**City of Bellevue  
Development Services Department  
Land Use Staff Report**

**Proposal Name:** Unique Green Homes Short Plat

**File Number:** 13-134761-LN

**Department Decision:** Approval with Conditions

**Figure 1 – Preliminary Short Plat Proposal**

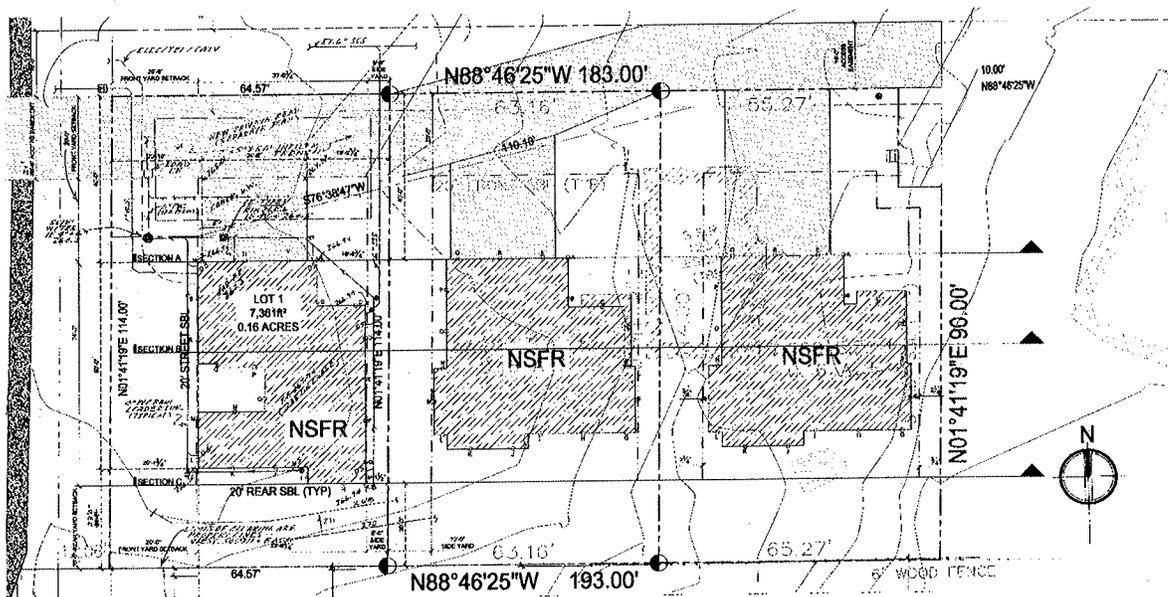
Lot 1 will have two front yard setbacks. One measured from the western property line which abuts Lake Washington Blvd SE and the second measured from the interior edge of the 20 foot access easement which traverses all three lots along the northern property line. This will allow for the southern property line to be designated as the rear yard and the eastern property line as a side which can go to five feet.

Lots 2 and 3's front yard setback will be measured from the interior edge of the shared access easement which runs along the northern property line of all three lots. Their rear yard setbacks will be measured from their respective southern property lines as they are the property lines directly opposite the property line designated as the front. These setback designations are consistent with Land Use Code definition of setbacks and the context of the built neighborhood.
